**HORIZONTAL DIRECTIONAL DRILL ANALYSIS  
WETLAND J-47 CROSSING  
PADEP SECTION 105 PERMIT NO.S:  
PA-LE-0001.0000-SR & PA-LE-0001.0000-SR-16  
(SPLP HDD No. S3-0090)**

**WETLAND J-47 CROSSING  
PADEP SECTION 105 PERMIT NO.S:  
PA-LE-0001.0000-SR & PA-LE-0001.0000-SR-16  
(SPLP HDD No. S3-0090)**

RE: Sunoco Pipeline, L.P. Pipeline Project - Mariner East II  
Wetland J-47 Horizontal Directional Drill Location (S3-0090)  
Hydrogeological Reevaluation Report  
Conewago Township, Dauphin County and  
South Londonderry Township, Lebanon County, Pennsylvania  
RETTEW Project No. 096302011

Figure 4. Revised 16-Inch Plan and Profile

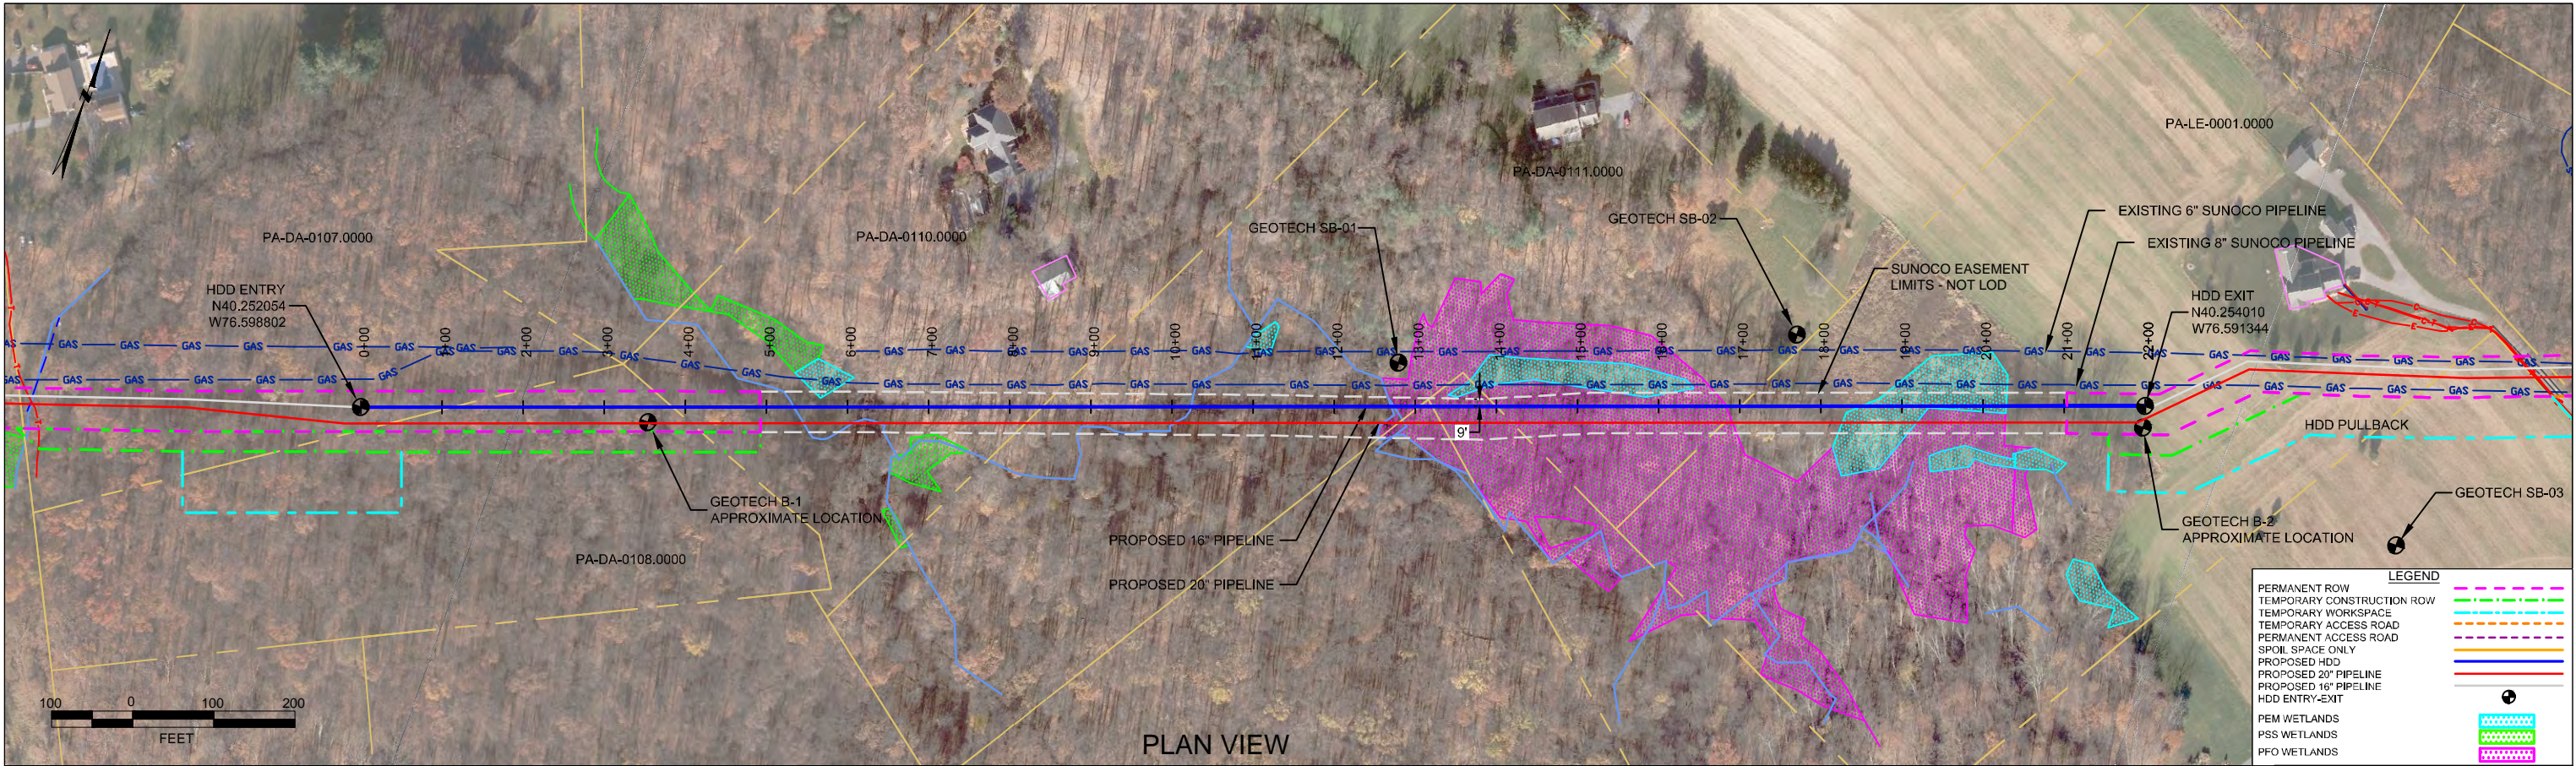
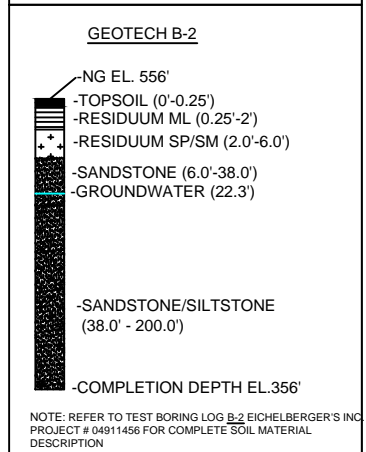
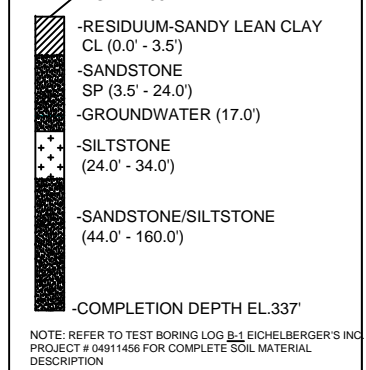
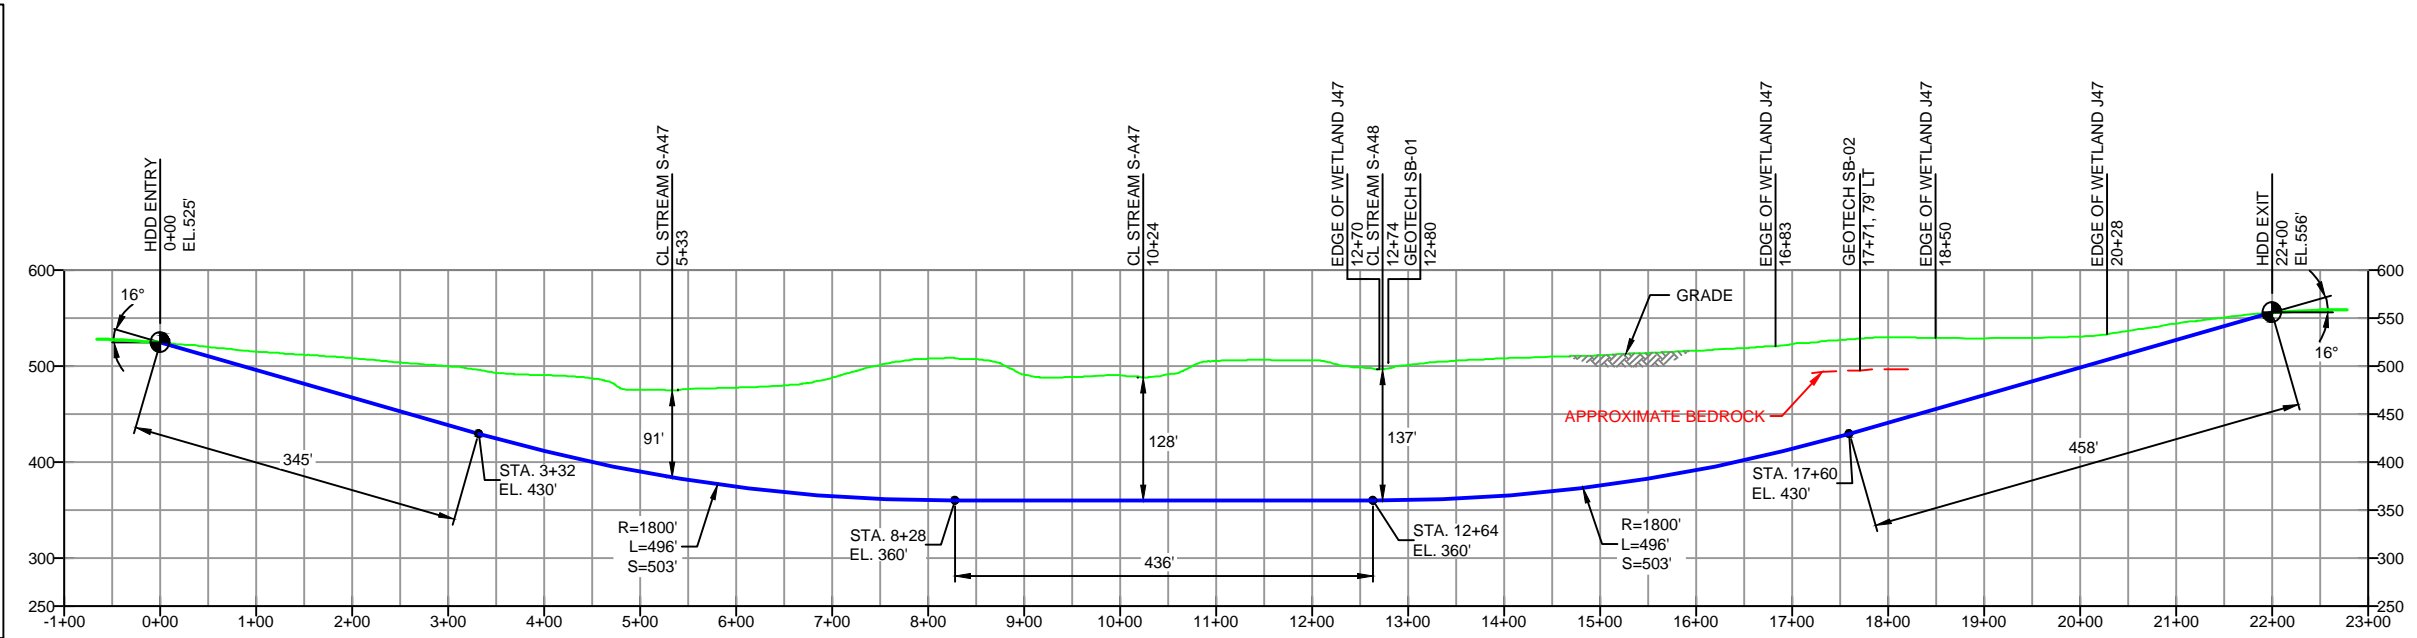
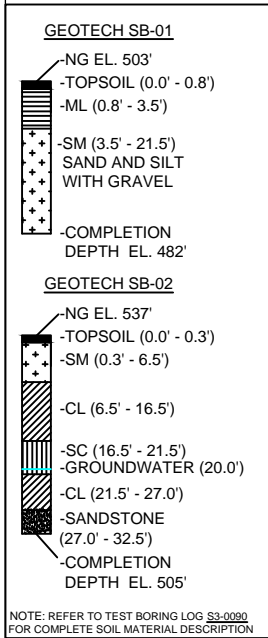
As presented and discussed in the Conclusion section below, the profile for both the 16 and 20-inch pipelines have been redesigned so that they are longer and deeper, and with the maximum degree of entry and exit angles allowed by the stress radius of the pipelines, to sharpen the pilot run down to horizontal depth and return exit to the land surface.

As shown on Figures 2 and 4 in Attachment 2, the weakest point in both profiles is the first stream undercrossing, occurring at Station 5+66 on the 20-inch profile, and Station 5+33 on the 16-inch profile. The revised design profiles provide for 78 ft of cover above the 20-inch pilot drill, and 91 ft of cover over the 16-inch pilot drill.

- Horizontal length: 2,200 ft
- Entry/Exit angle: 16 degrees
- Maximum Depth of cover: 137 ft
- Pipe design radius: 1,800 ft
